APPLE VALLEY PROJECT

NCDMS Project #100063 (Contract #7531)
USACE Action ID: SAW-2018-01150
DWR Project #20181028

RE: Apple Valley Site: Year 3 Monitoring Report

Listed below are comments provided by DMS on January 18, 2024 regarding the Apple Valley Site: Year 3 Monitoring Report and RES' responses.

Antecedent Precipitation vs Normal Range based on NOAA's Daily Global Historical Climatology Network

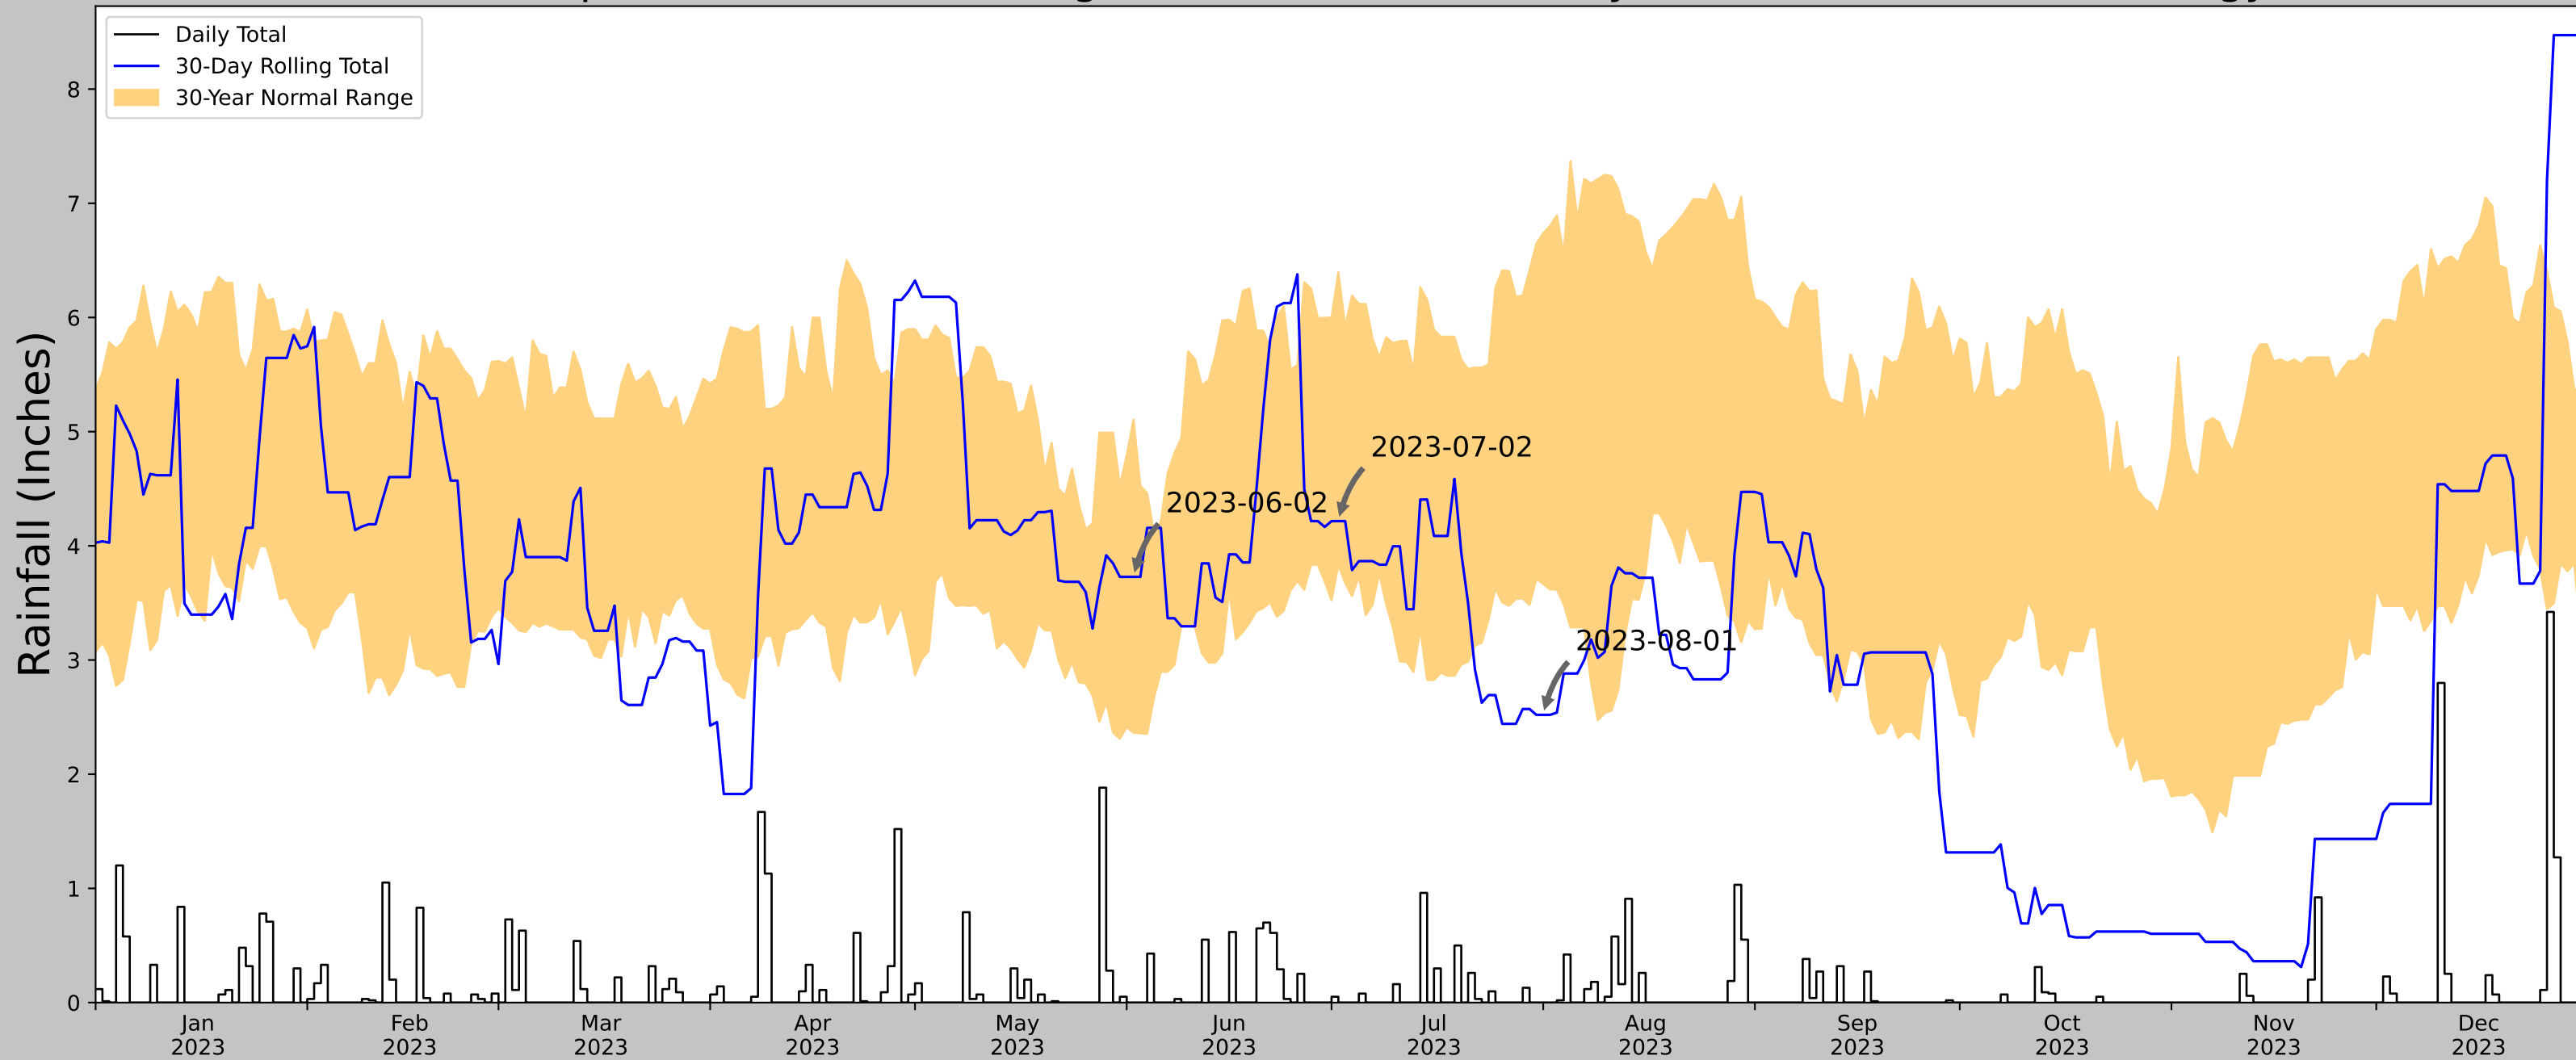
Can a 30-70 rainfall graph be provided along with the table? This would be helpful.

The 30-70 rainfall graph that was generated by the Antecedent Precipitation Tool was included in the report. Please let us know if this is not sufficient.
